AIRWORTHINESS DIRECTIVE

Cessna 206 Series Aeroplanes

**AD/CESSNA 206/48
Amdt 2**

Forward Door Post Bulkhead

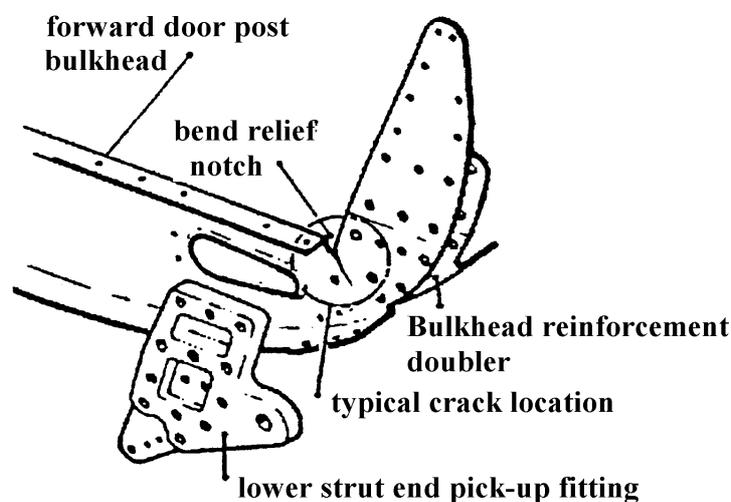
1. Visually inspect for cracks at the inside edge of the left hand and right hand bend relief notches of the forward door post bulkhead.
2. Visually inspect for loose or working fasteners securing the lower strut end pick-up fitting to the forward door post bulkhead. The inspection areas and typical crack location are shown in the diagram below.

Note 1: Inspection in accordance with Requirement 1 will initially require removal of certain floor panels. Incorporation of inspection holes in accordance with an approved modification will allow inspection of the relief notch without requiring removal of the floor panels.

Note 2: Inspection in accordance with Requirement 2 may be accomplished from outside the aircraft via the hole exposed by removing the lower wing strut fairing.
